CNL-17-102

Subject: Submittal of Supplemental Information Related to Emergency Planning
Correspondence Between Tennessee Emergency Management Agency and
Tennessee Valley Authority in Support of Early Site Permit Application for
Clinch River Nuclear Site

Supplemental Information Related to Emergency Planning Correspondence Between
TEMA and TVA

TVA-TEMA Correspondence Letters

Description of the Clinch River 2-Mile EPZ

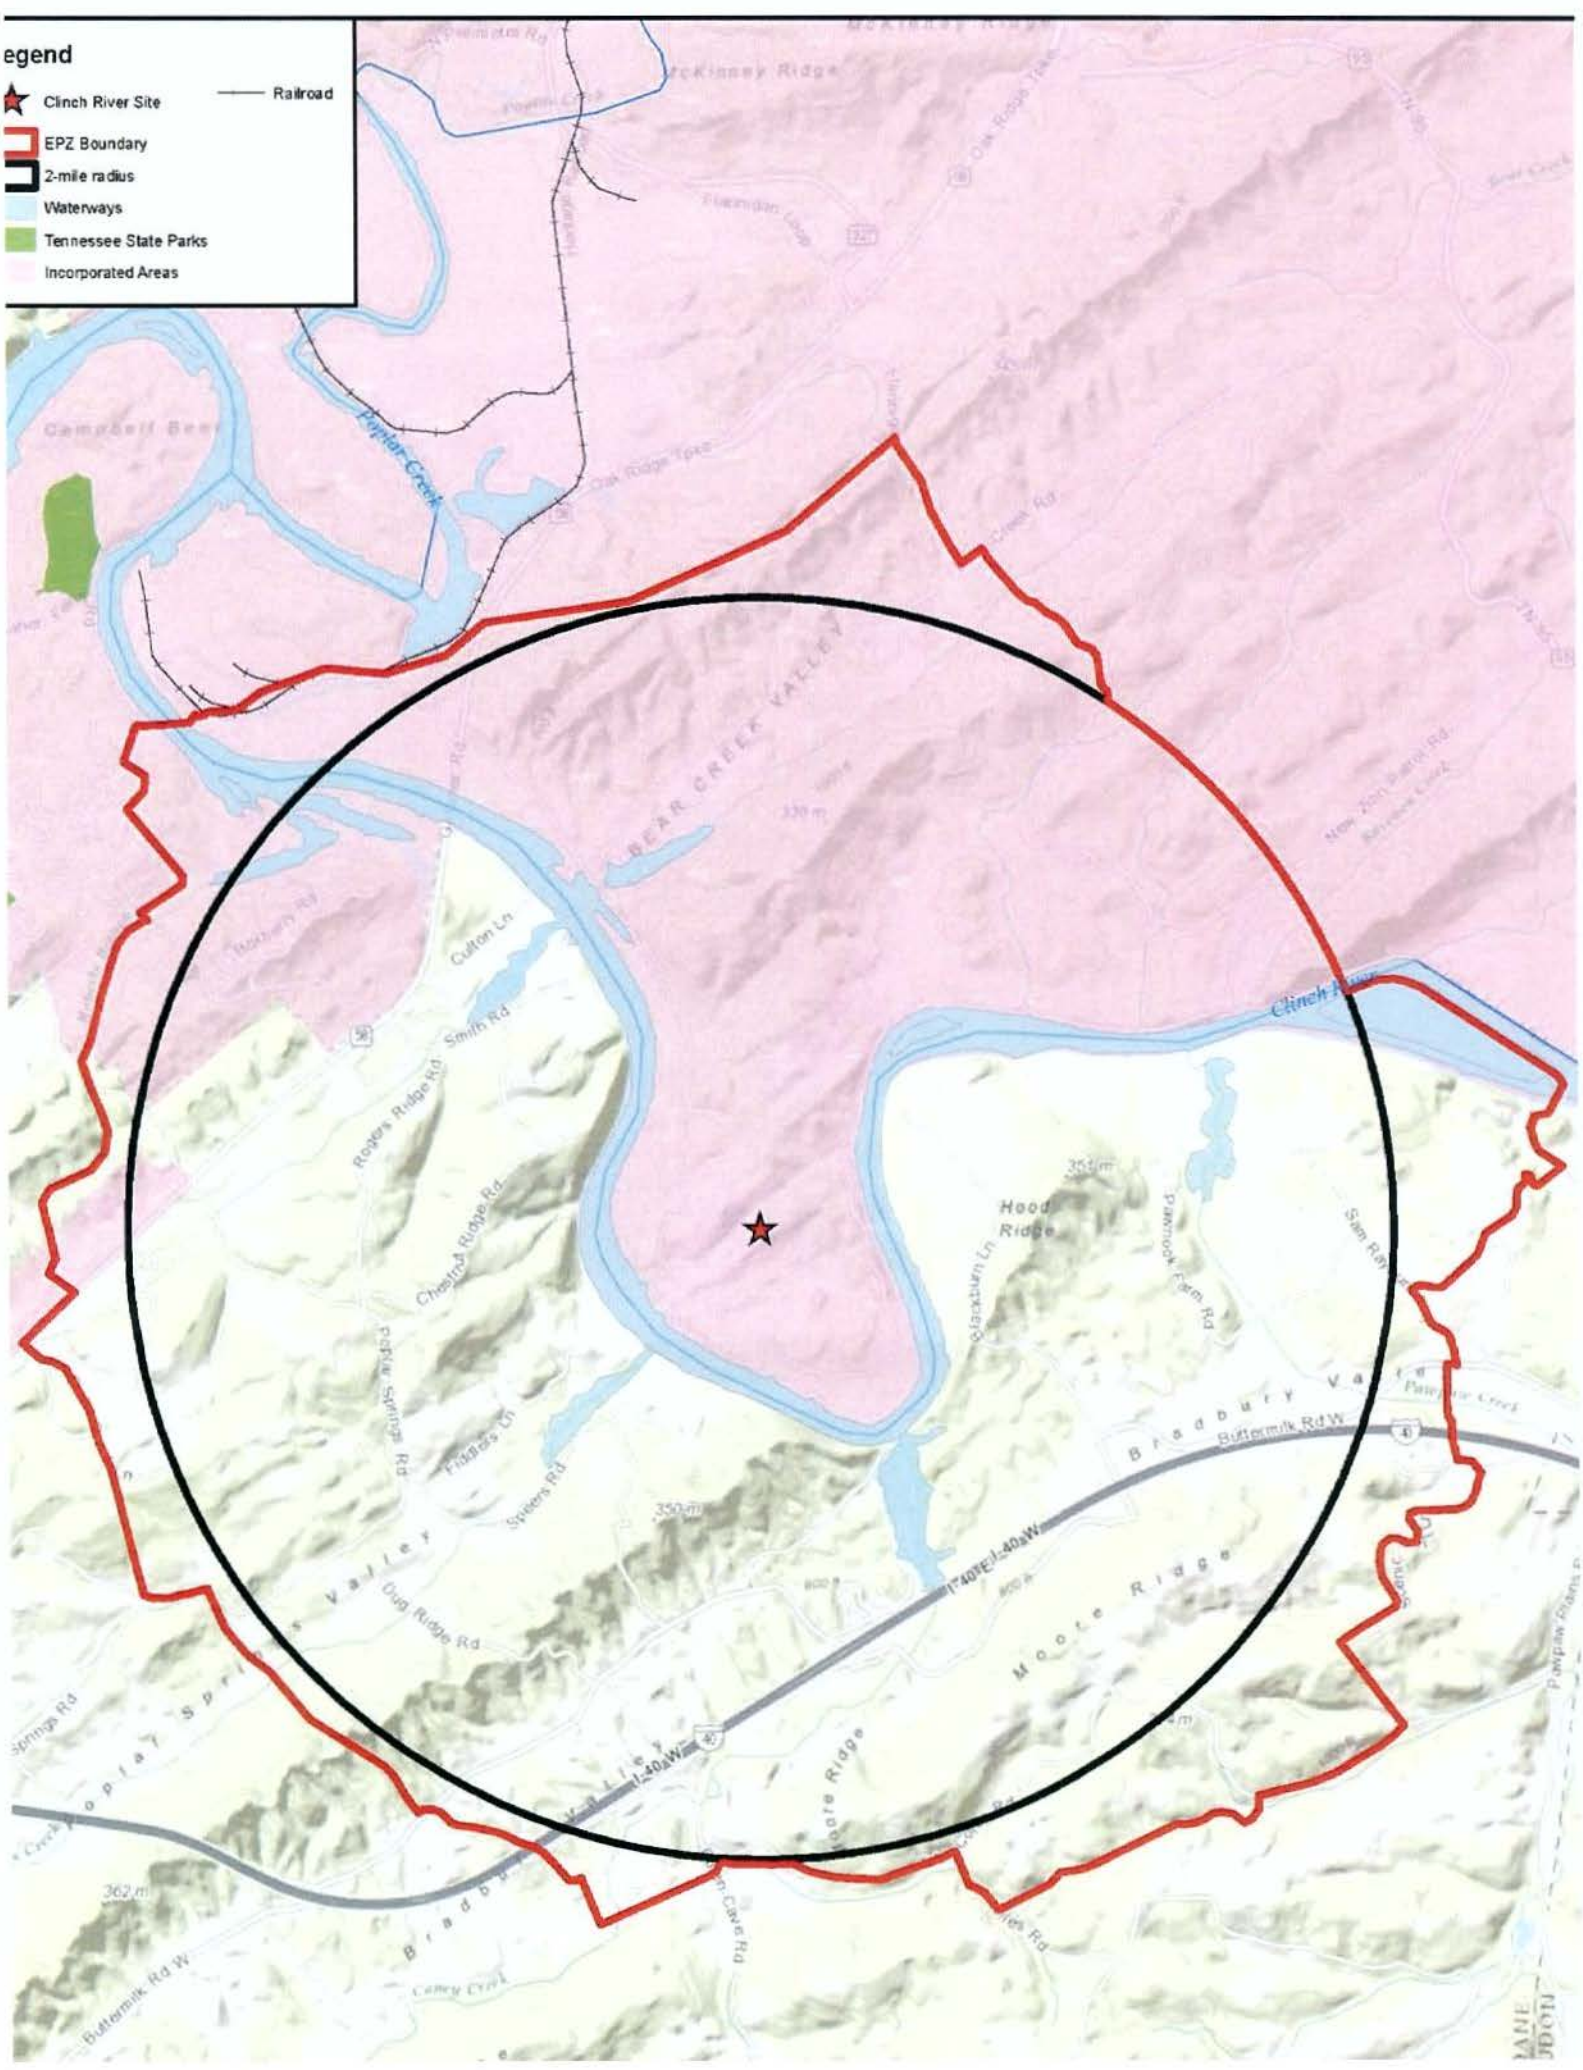
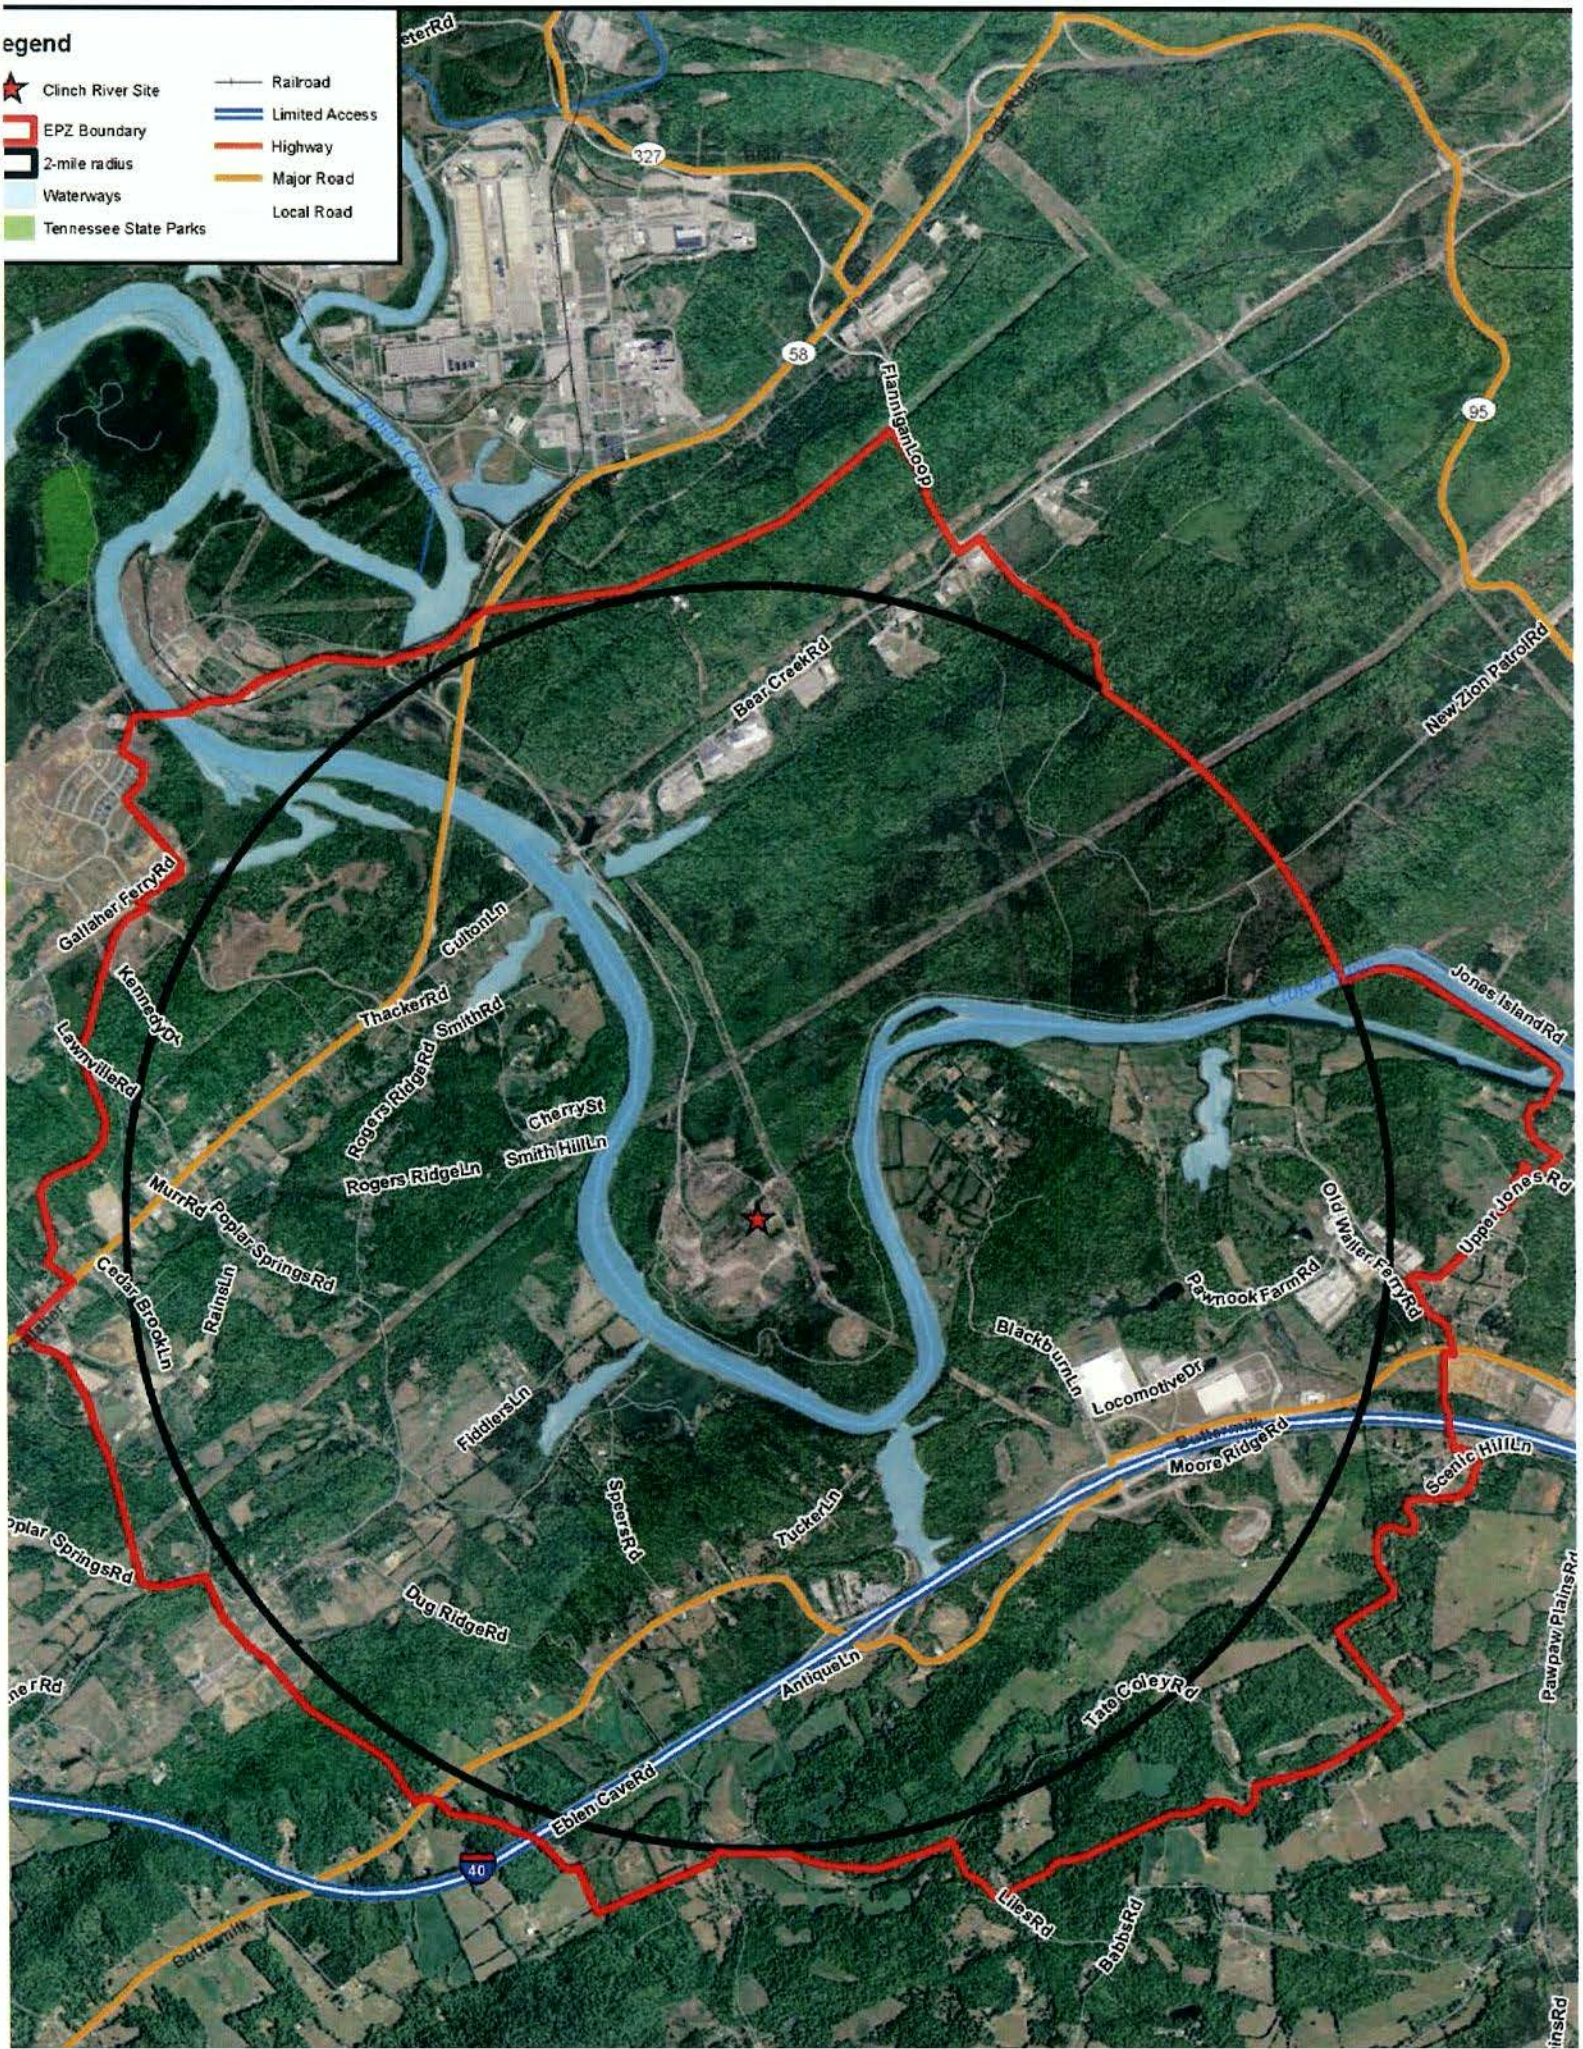
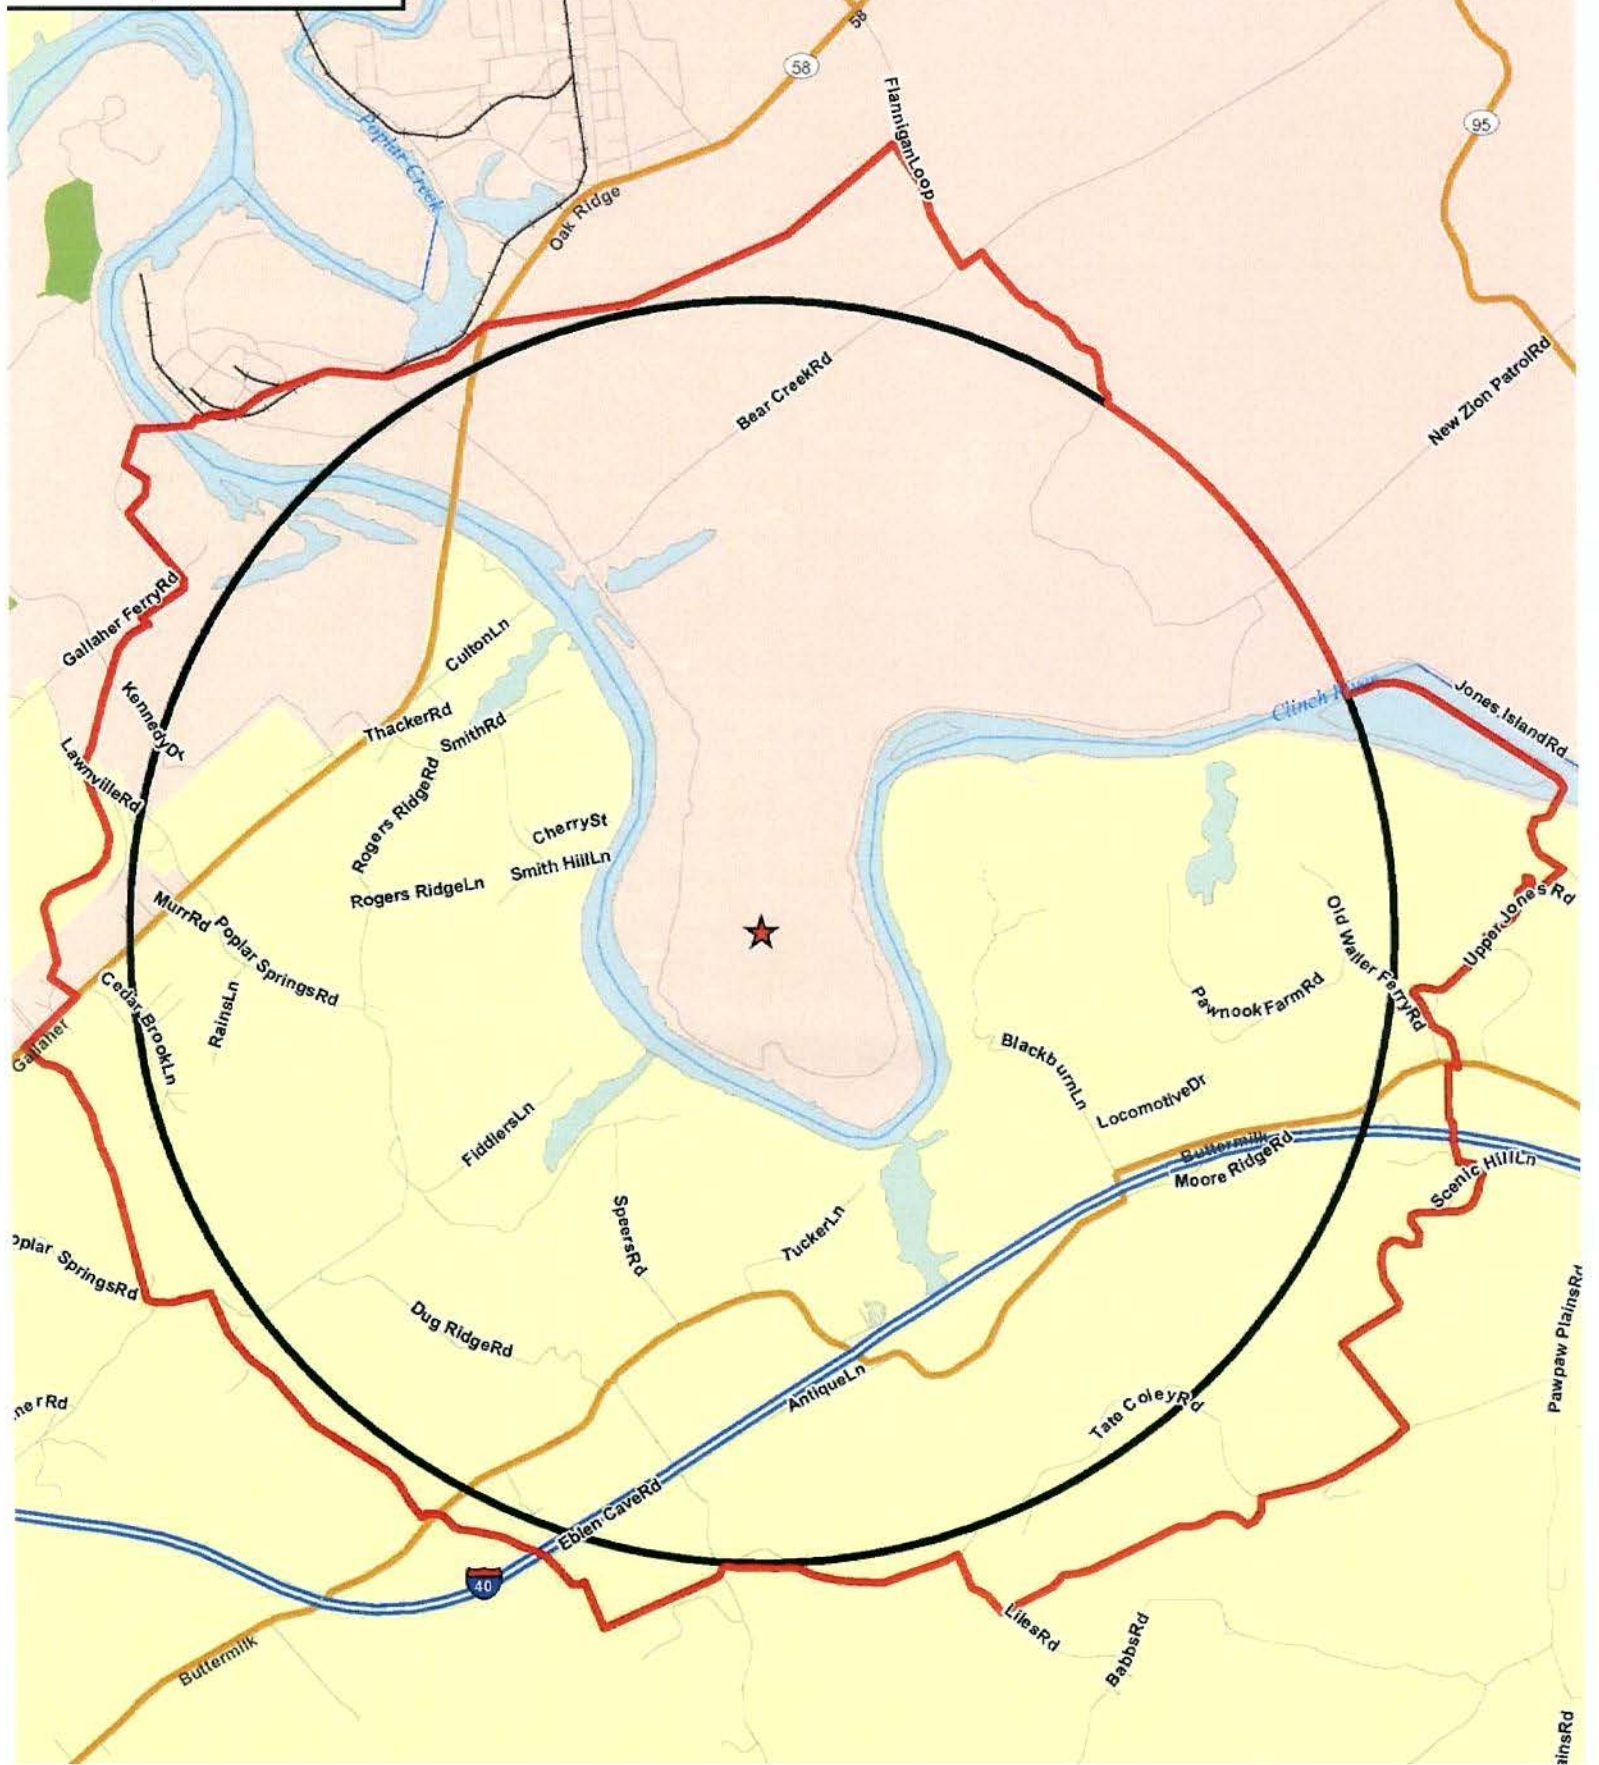
17, 2014 S.H.
On December ~~12, 2015~~, staff from the Tennessee Emergency Management Agency (TEMA) participated via conference call in the public presentation by the Nuclear Energy Institute and TVA to the Nuclear Regulatory Commission (NRC) staff regarding the proposed SMR mentioned above. At the conclusion of this presentation, the NRC staff made the determination that it was not given sufficient information to make a recommendation to the NRC regarding the appropriateness of a fence line or 2 mile EPZ. TEMA must concur with the NRC staff at this time that a determination of the EPZ for this proposed project is premature, given the lack of specific information on the nature and design of the proposed SMRs.

Specifically, information regarding the source term of the fuel for the SMRs needs to be identified. Additionally, specific information on the SMR's design and passive safety systems must be made available for review before any EPZ recommendation can be supported. We also concur with Roane County that an Emergency Alert System which is compatible with the system used by the Department of Energy is needed. Until these and other technical questions have been addressed, sufficient information is simply not available to make a determination regarding the appropriate EPZ for this proposed project.

TEMA will remain a strong supporter of this project and will gladly voice this support to the NRC. However, until more complete technical information is available and the Draft Evacuation Time Estimate study is reviewed, we are not in a position to comment one way or another regarding the appropriate EPZ for the project.
